From: Ashley Cardiff
Sent: 8/03/2024 9:42:18 AM
To: Council Northernbeaches Mailbox
Subject: TRIMMED: DA 2024/0134 - Objection Letter.
Attachments: Objection Letter - 7 Coonanga Rd.pdf;

Development Application: DA2024/0134.

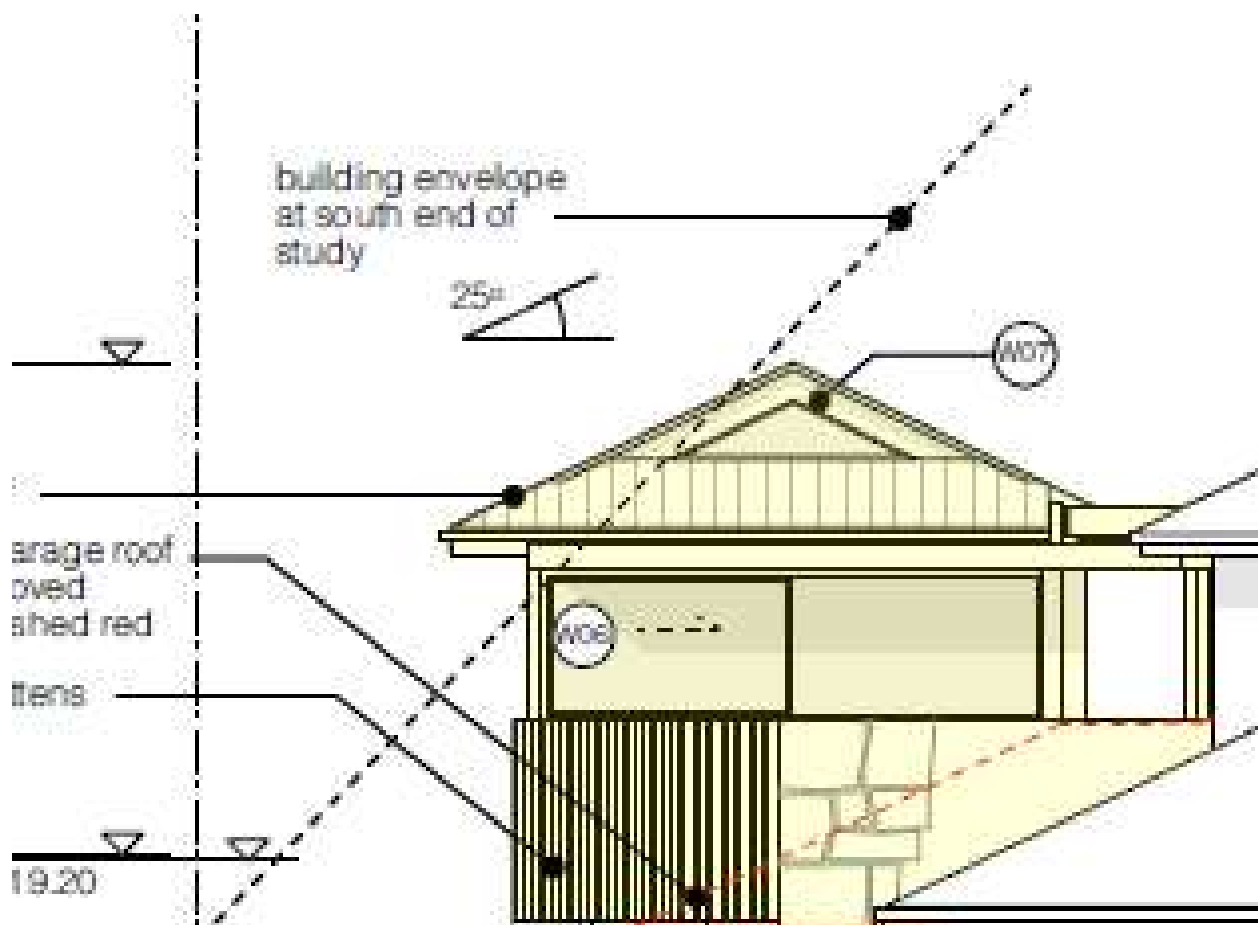
The SEE states “***The window openings to the side elevations set back from the western boundary and given the low frequency nature of the proposed study use, the new works are not considered to result in any unreasonable overlooking.***”

This statement is misleading as there is no way of ensuring “low frequency nature of the proposed study use.” The proposed study is 9.2 x 4.4 metres, a very substantial room more in line with a professional office space. It shows two workstations. Given that a separate external entry stair is shown for this space and the room is separated from the house, it could easily be used for a commercial or home office with staff. More concerning is that the structure contains a separate bathroom and kitchenette and could easily be used or adapted to a secondary dwelling.

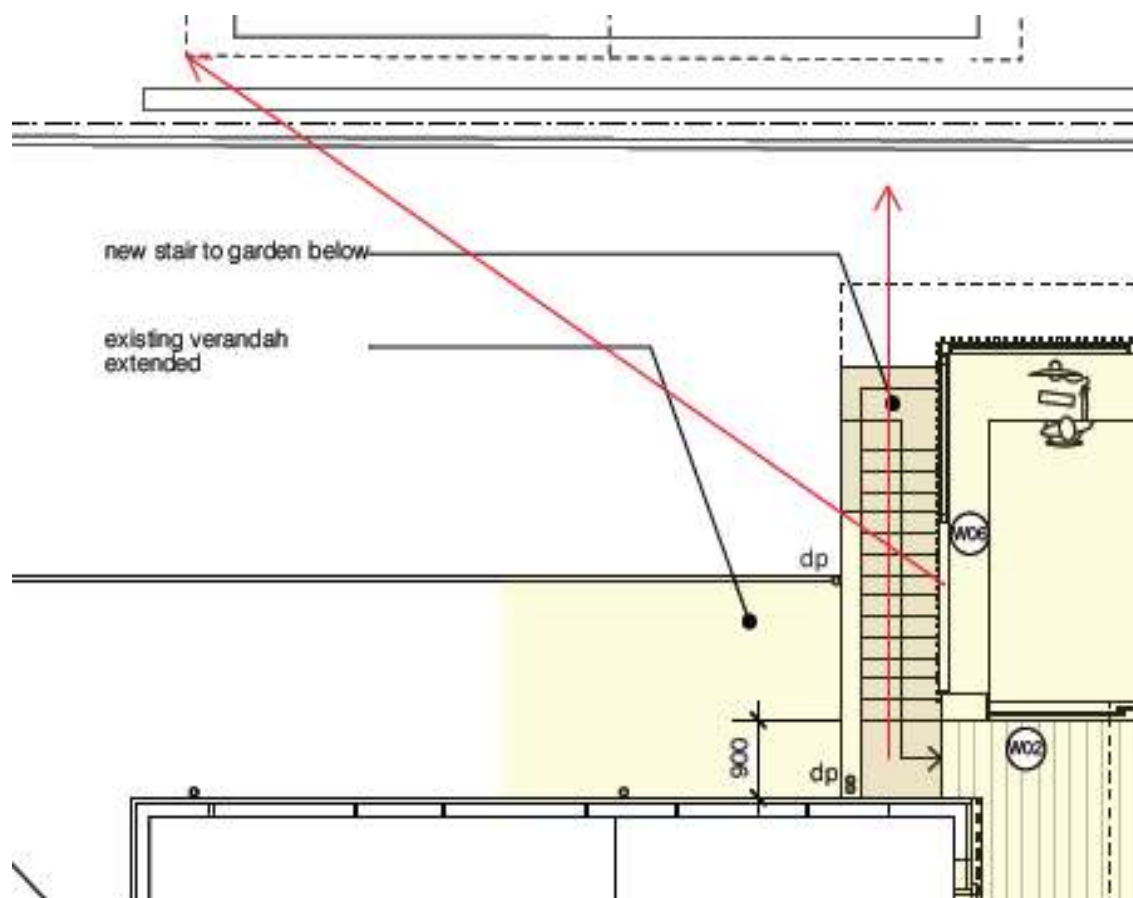
Further to the stairway construction, the construction of a landing and the extension of the veranda from the rear of the property to meet the stairway has increased the building footprint (as indicted below) and as such I contest that the landscape area is compliant with the required development control. Has the addition to the footprint as stated above and the removal of the concrete driveway been correctly assessed as part of landscape area in relation to the overall site area?

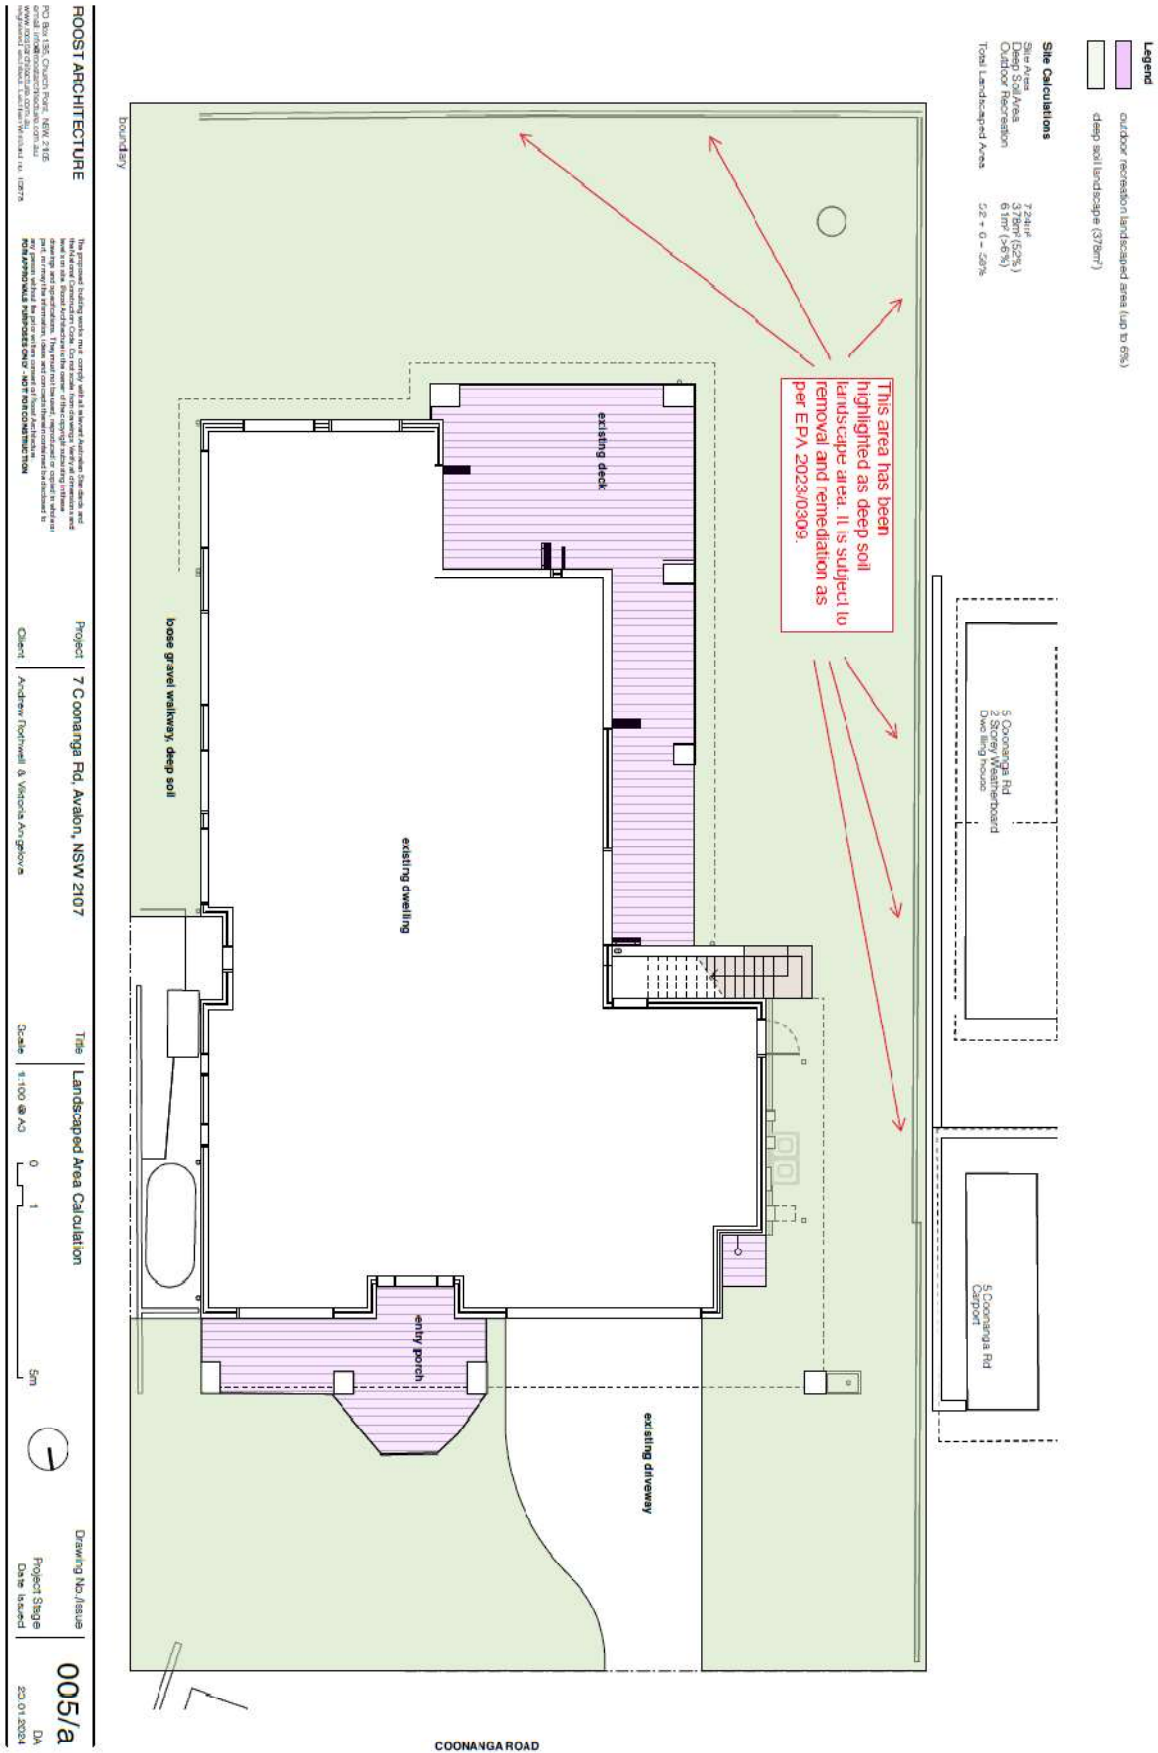
I am submitting some drawings and photos below to support my position and provide some additional context.
